August 1, 2024  
AVO 37449.004

**Re: Greystar Multifamily -Review #1**

Halff was requested by the City of Sanger to review the Final Plat and Civil drawings for the Greystar Muti-family Development. The submittal was prepared by Clay Moore Engineering and was received on July 18, 2024.

OUTFALL

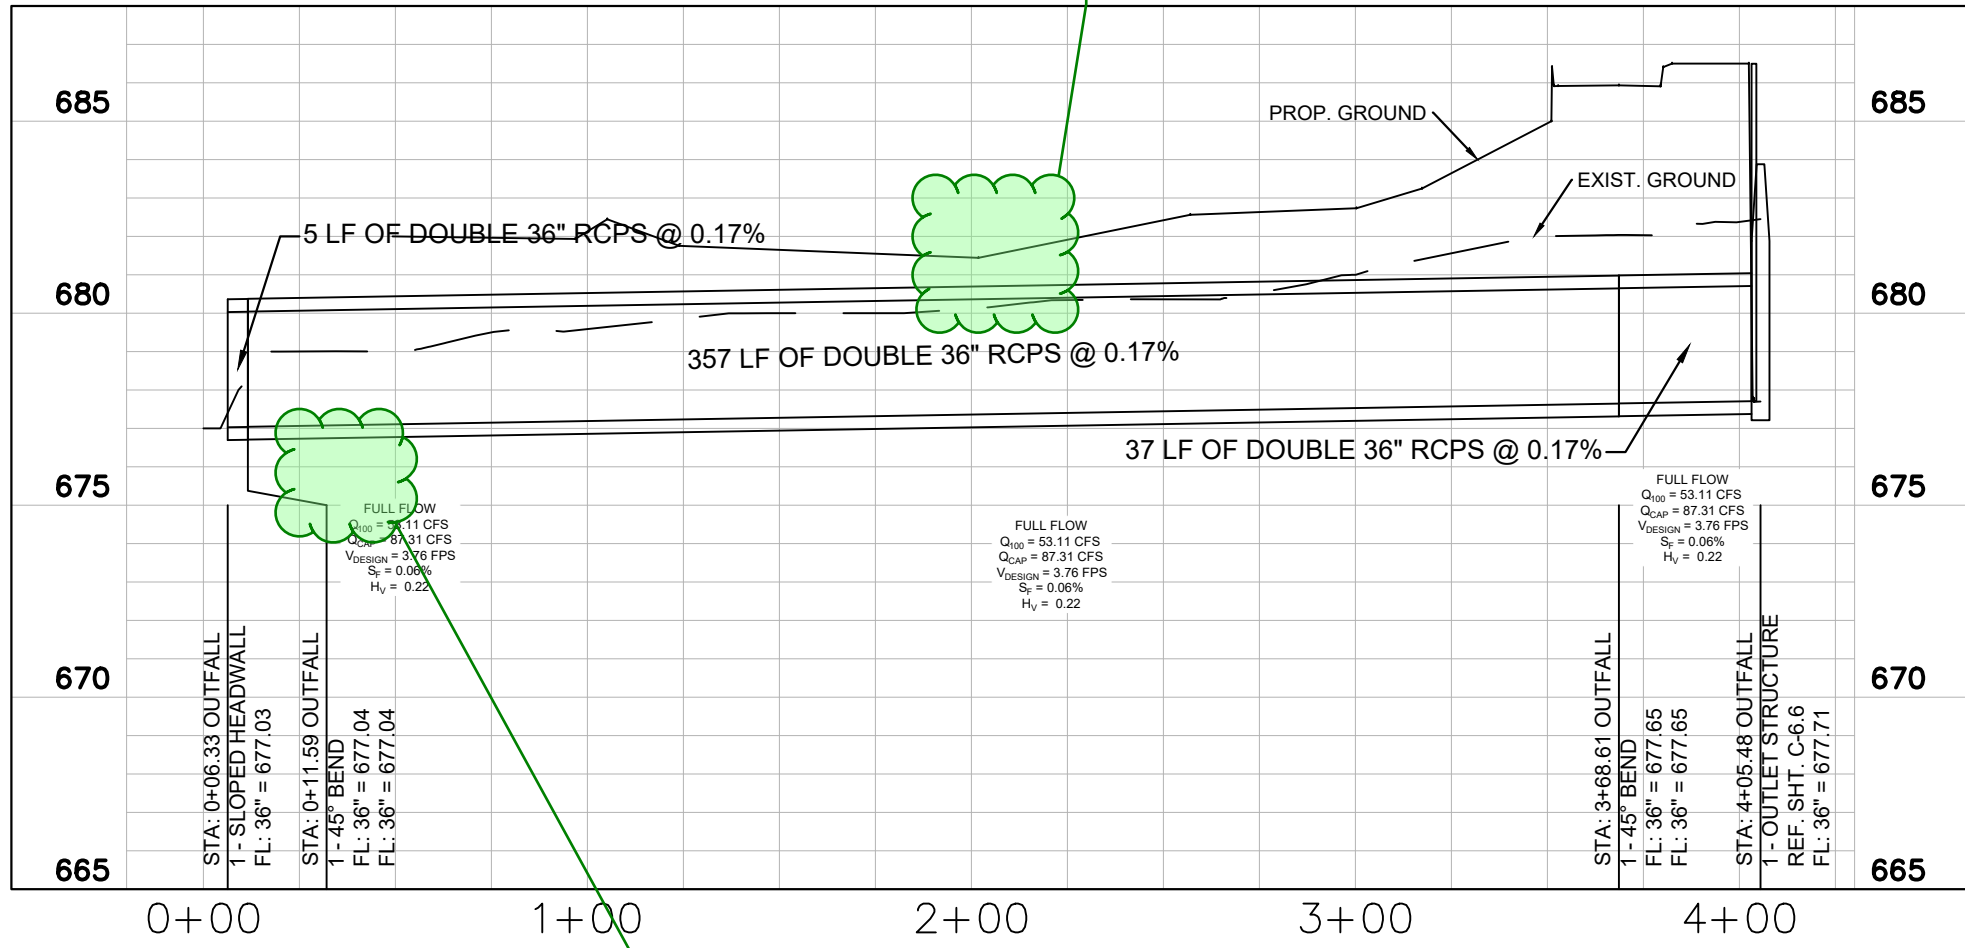
SS crossing per plan

WL crossing per plan

Less than 2' of cover.  
Provide class of RCP  
to be used or deload  
calcs for type III RCP

Clarify Ph1 vs Ph 2  
construction

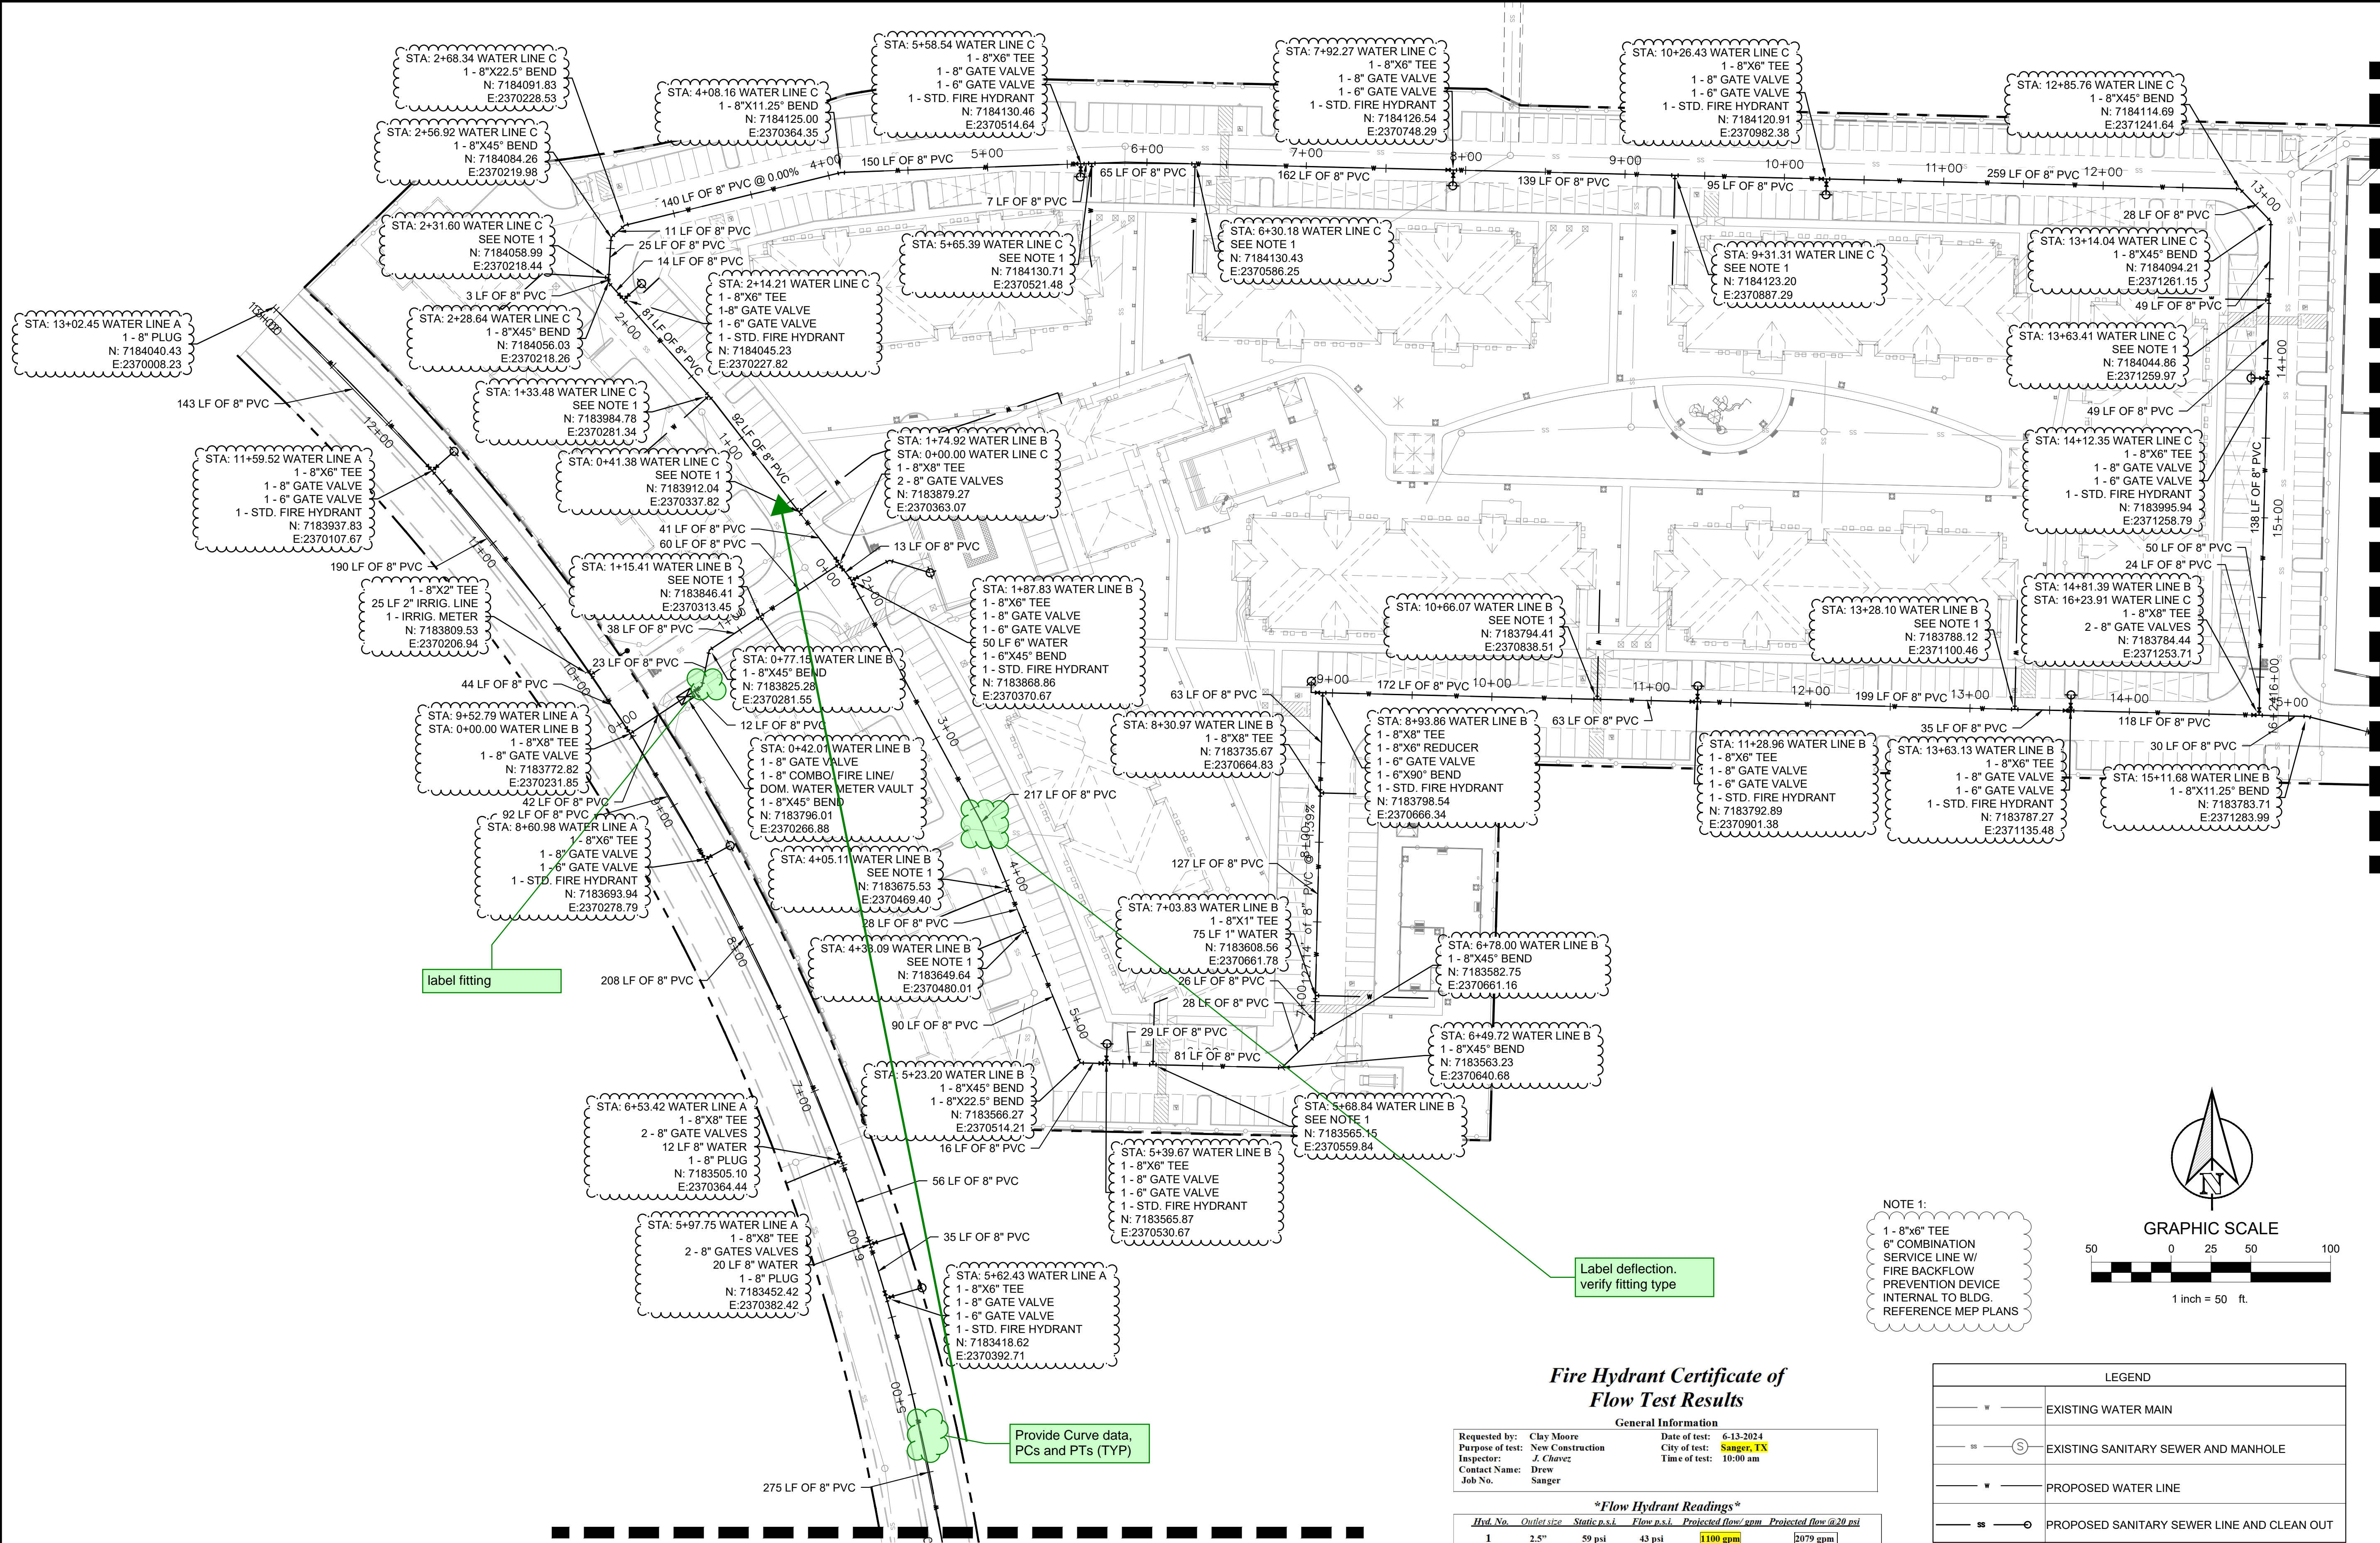
100 YR WSE  
 1 FT FREEBOARD  
 TOP OF POND  
 1' of freeboard and 2' of sediment storage required

SANITARY SEWER LINE B

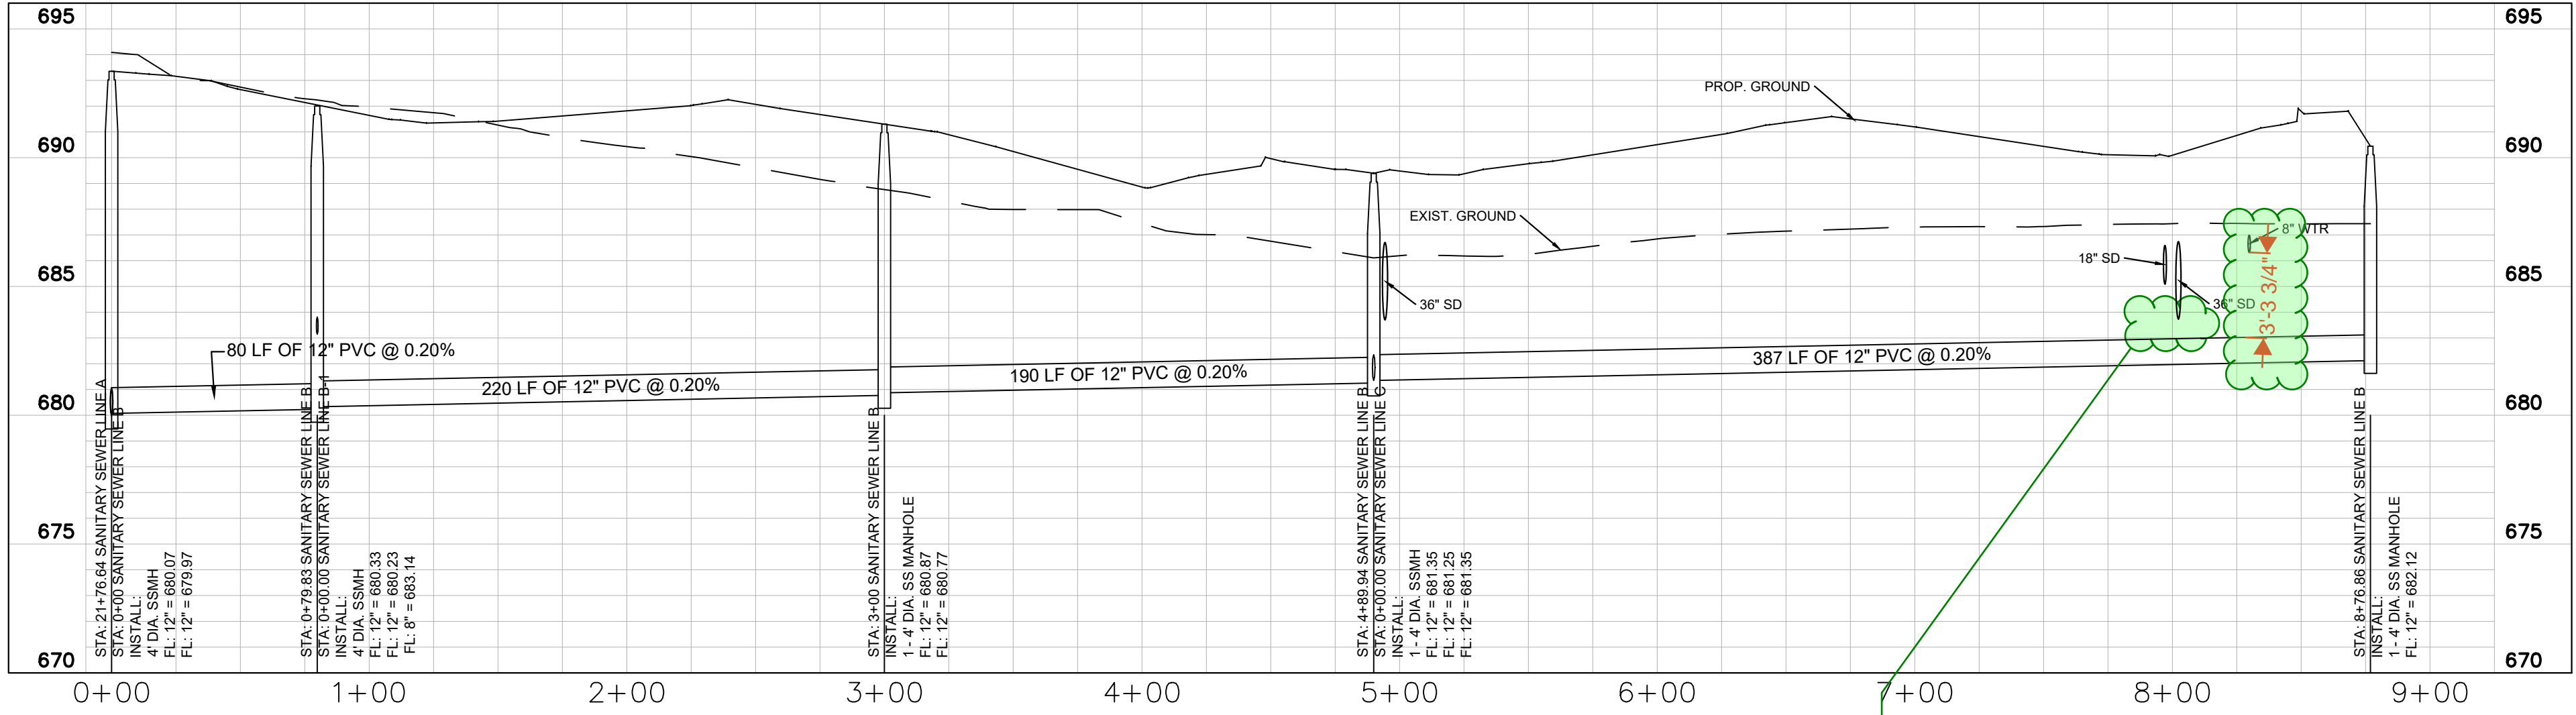
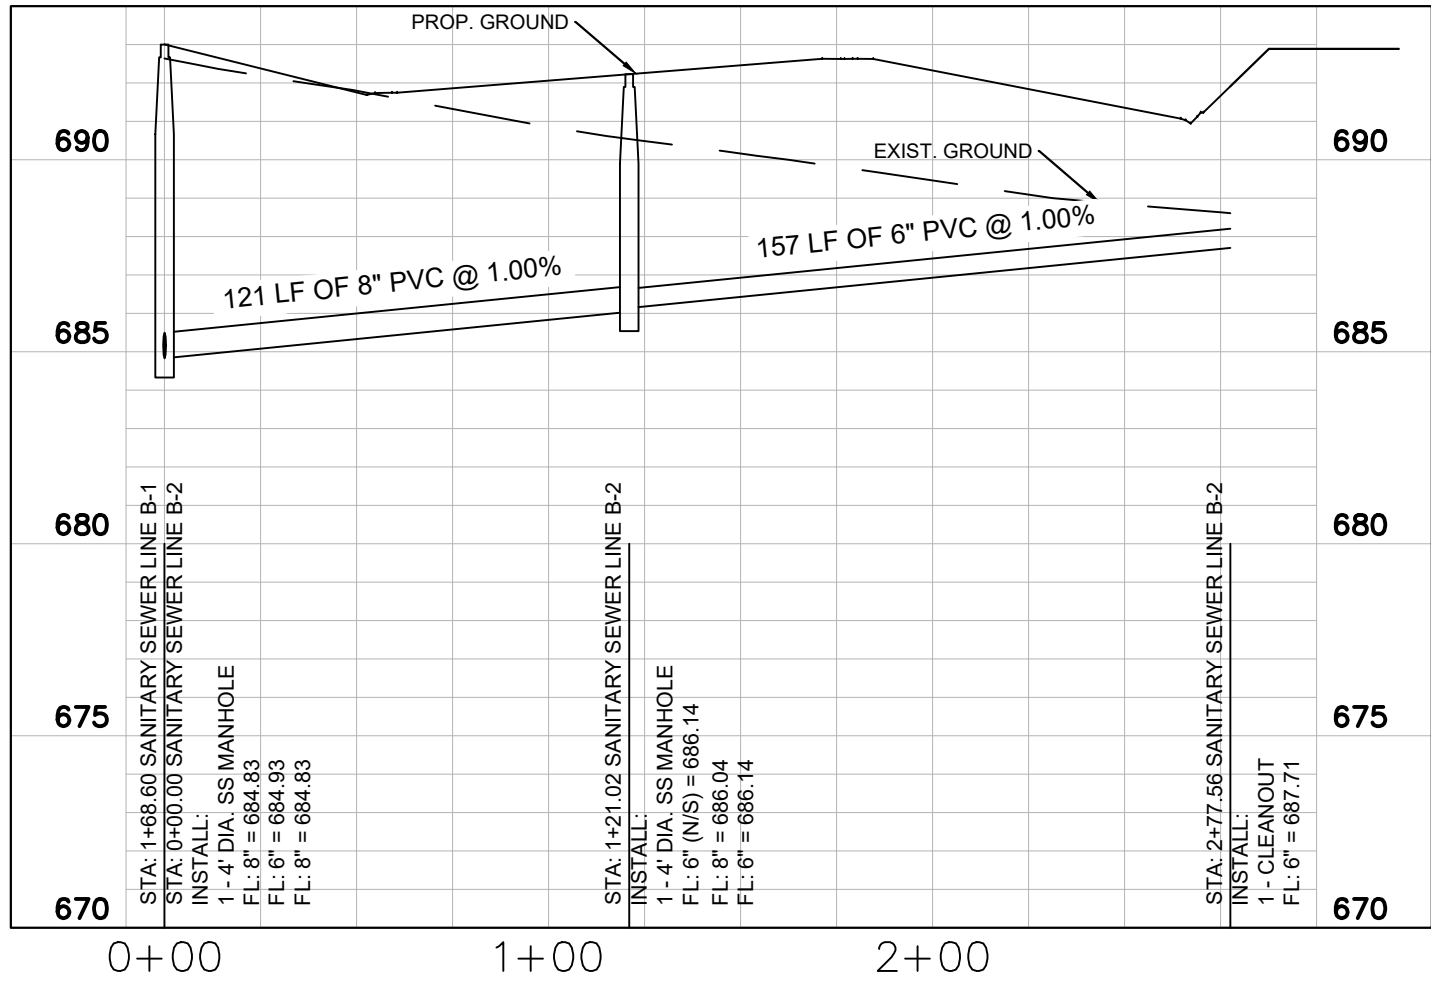
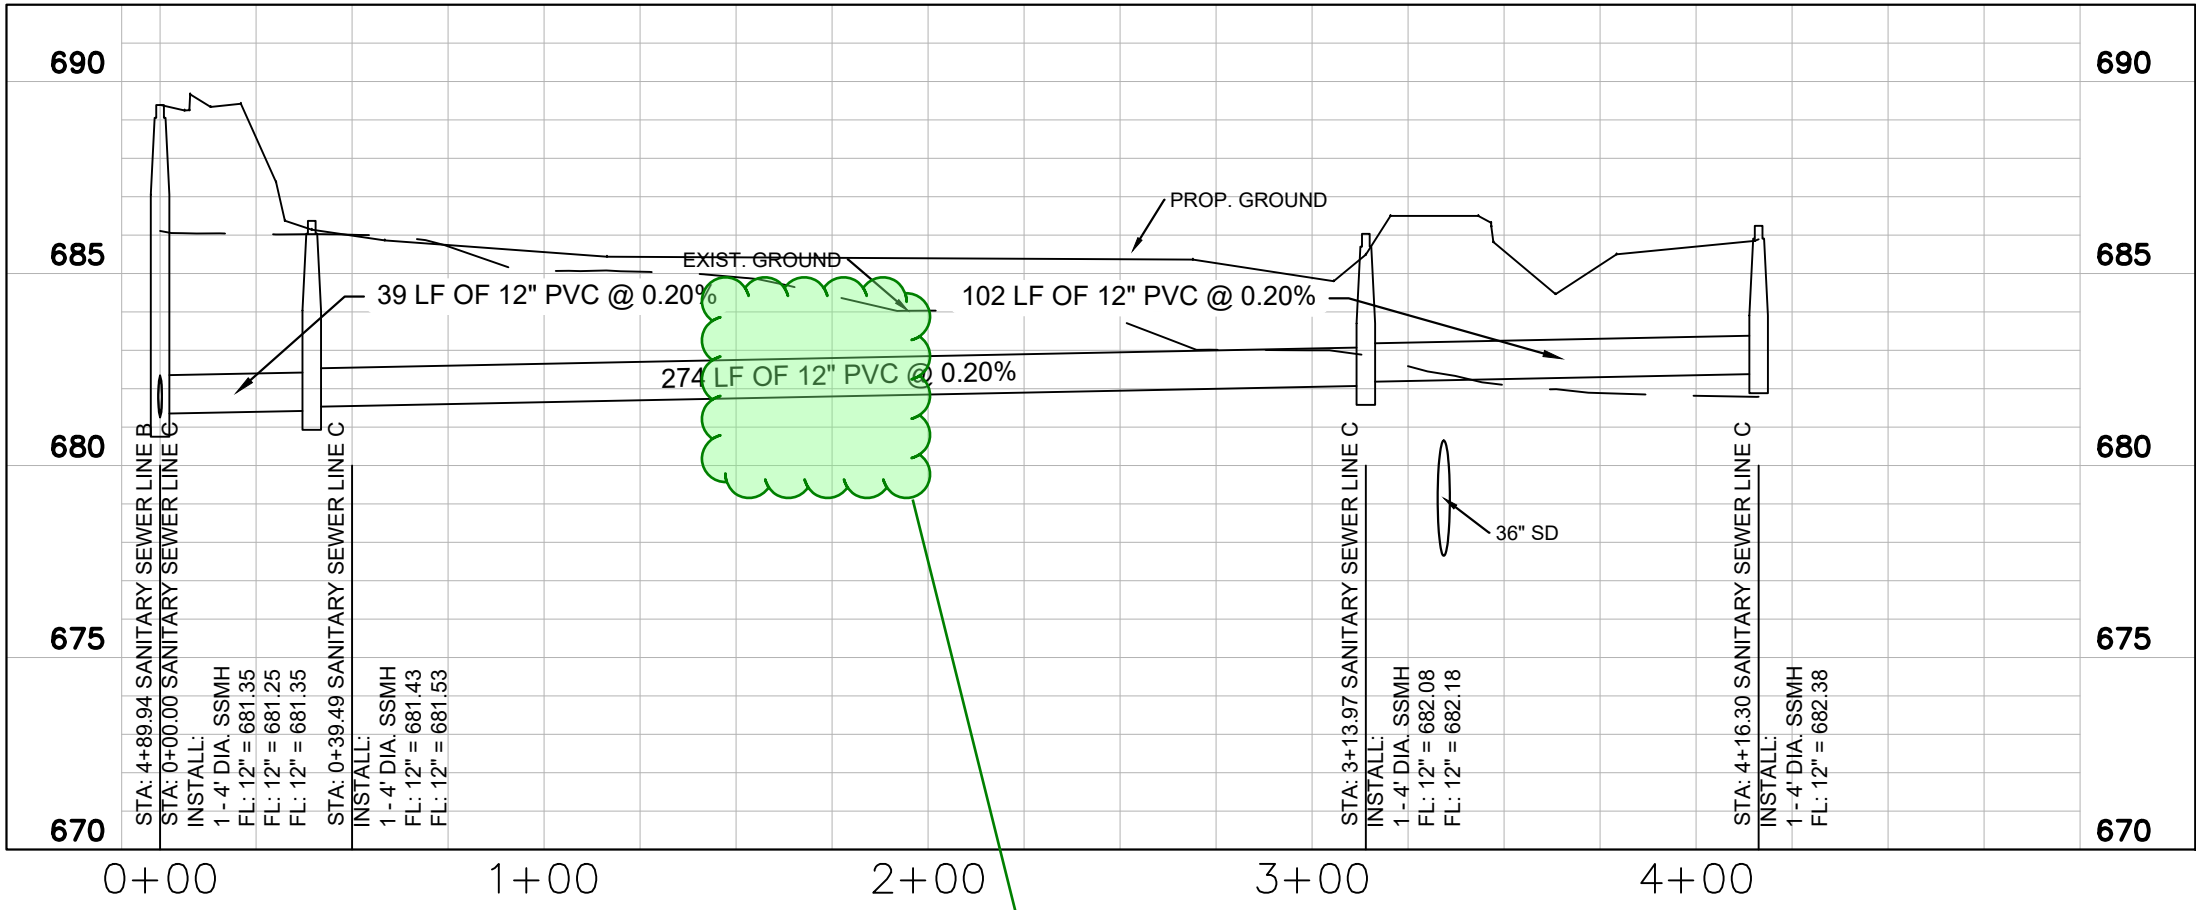
Min 2' desired. show how pipe will be properly protected with the storm install (TYP)

What type of embedment is to be used? Shallow line
